BOARD ACTION REPORT – APPEALABLE ITEM

Project Name: 405 South

Project Location: 405 SE 6th Avenue

SITE PLAN REVIEW AND APPEARANCE BOARD STAFF REPORT

SITE PLAN SCALE: 1/8" = 1'-0"

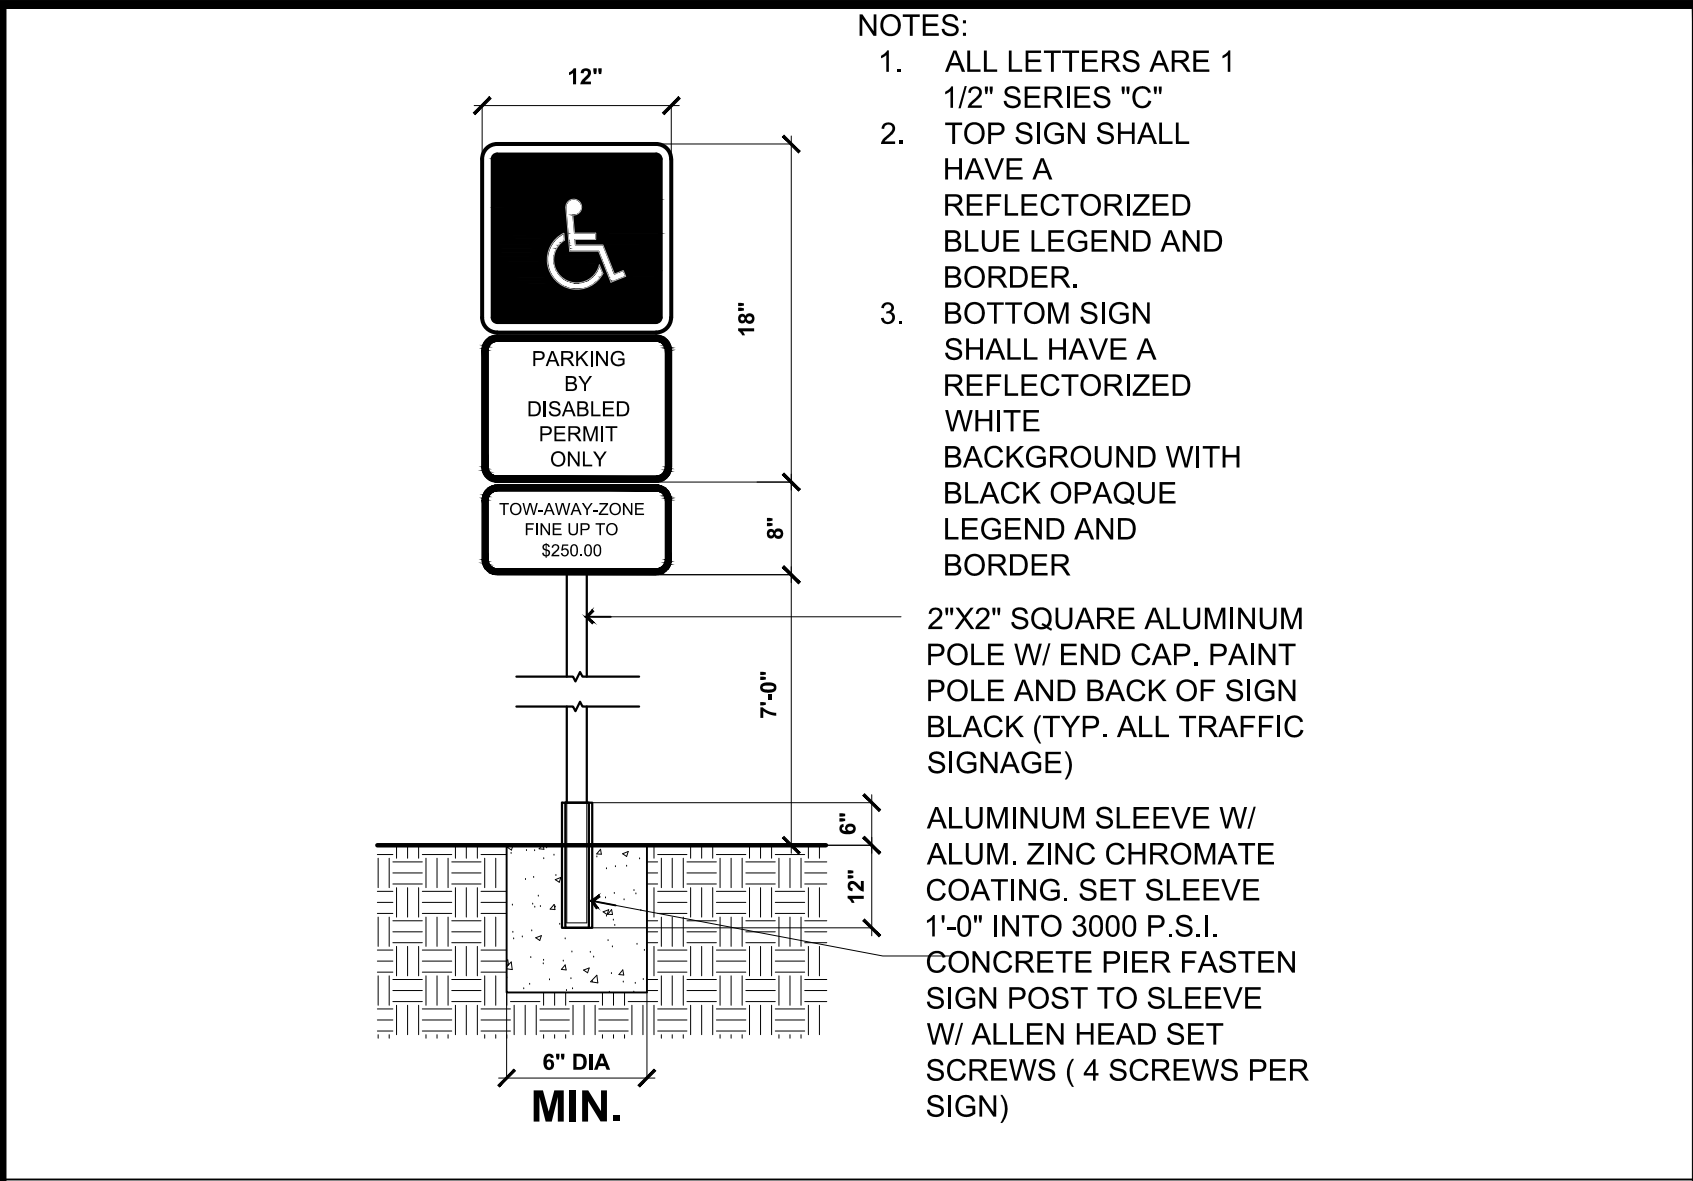
1. Prior to Site Plan Certification, the note stating Townhouses are fee simple shall be removed from SP-1 (Site Plan) and replaced with a note stating all units will be leased.
2. Prior to issuance of building permit, a Landscape Maintenance Agreement for street trees shall be recorded.
